ADDENDUM NUMBER ONE

Indiana University
Launch Accelerator for Biosciences
1302 Indiana Ave.
Indianapolis, IN 46202

Addendum Dated: OCT 16, 2025

IU Project #: 20250072
BSALS Project #: 00360481

S302

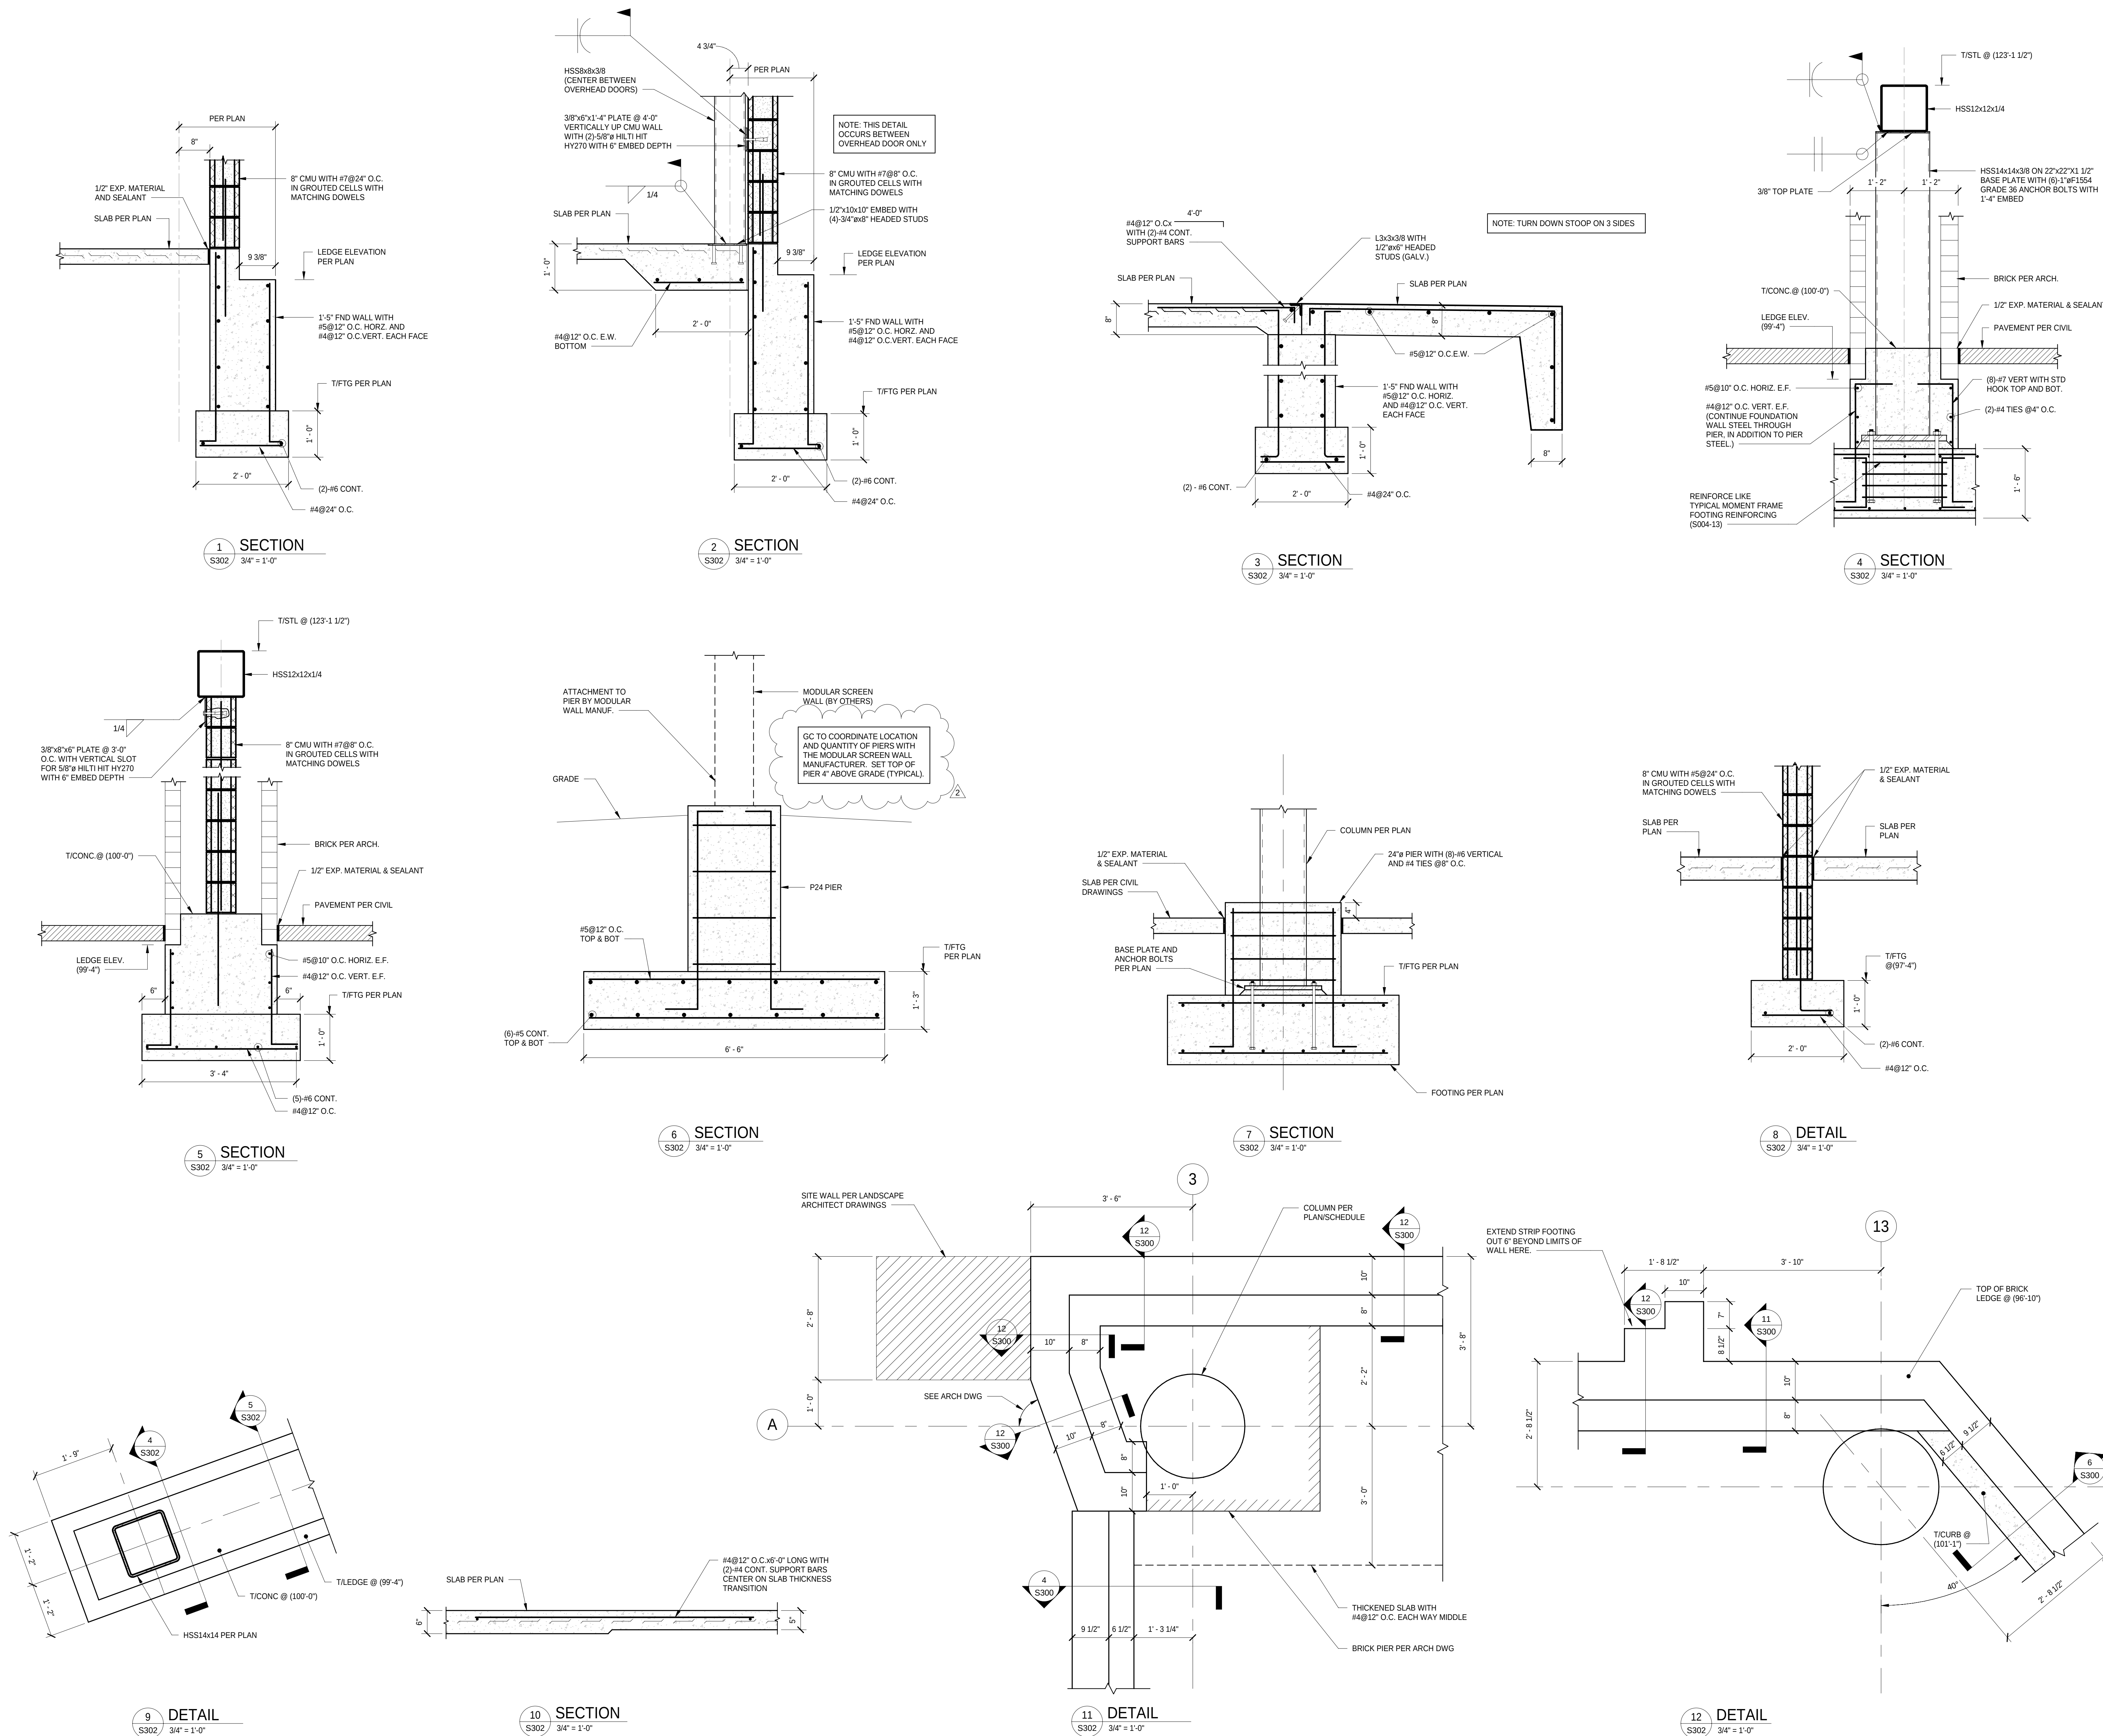
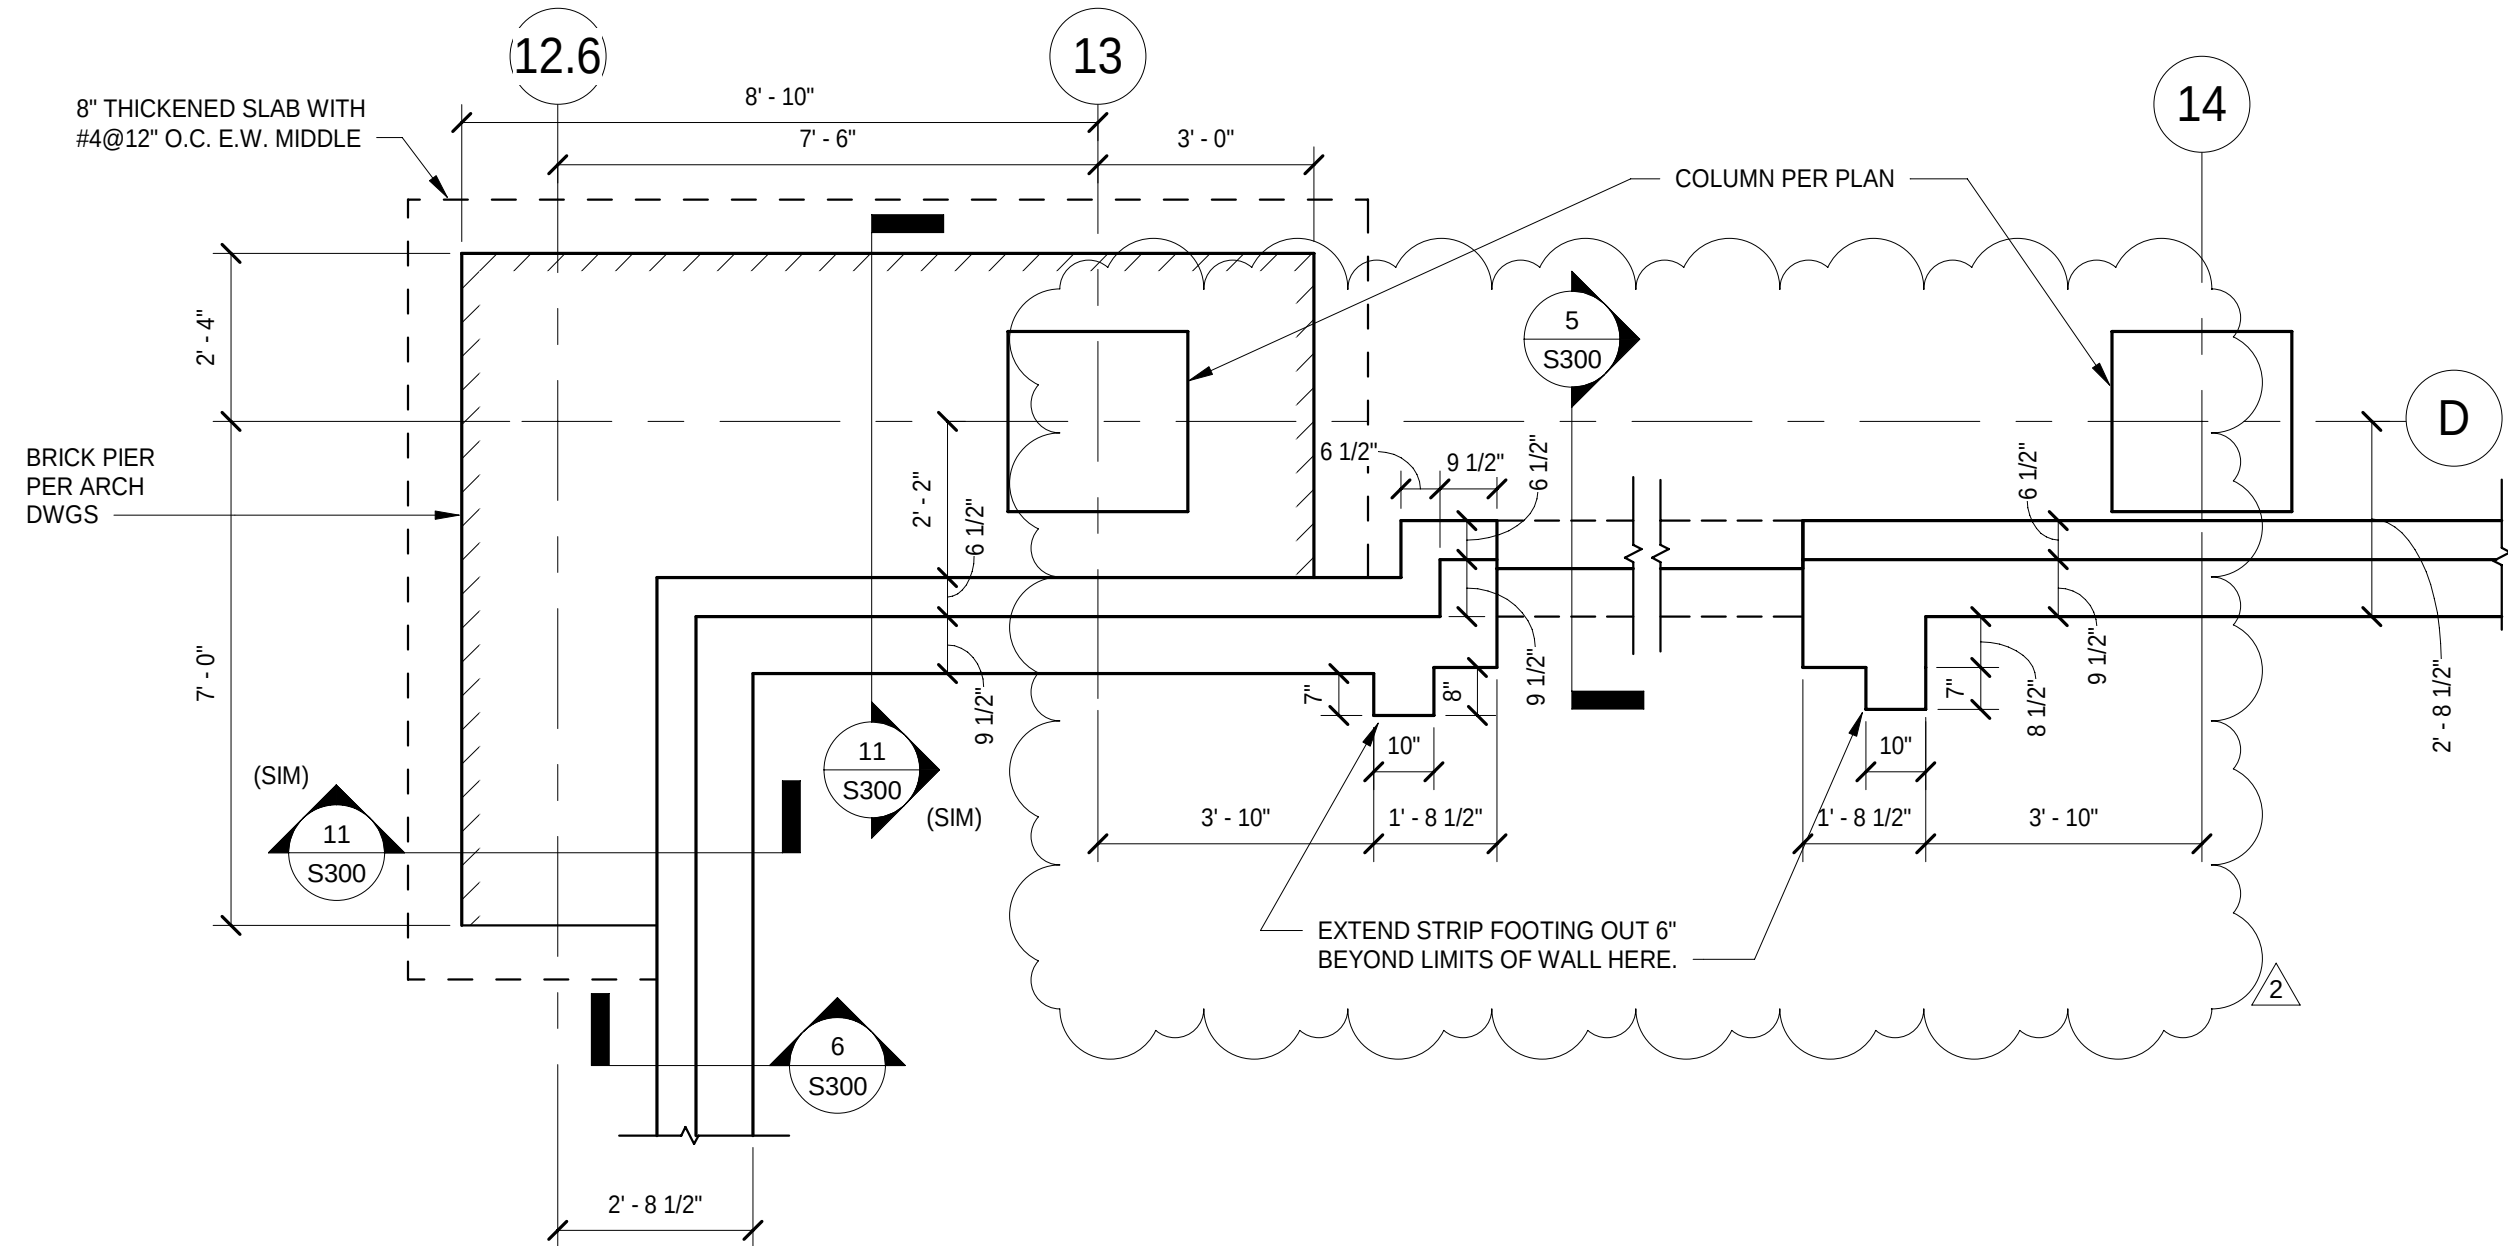
13. **Sheet S301:**
- a. Modify the dimensions on detail S301-06 as shown on the clouded portion of the attached revision drawing.
14. **Sheet S302:**
- a. Add the note to section S302-06 as shown on the clouded portion of the attached revision drawing.
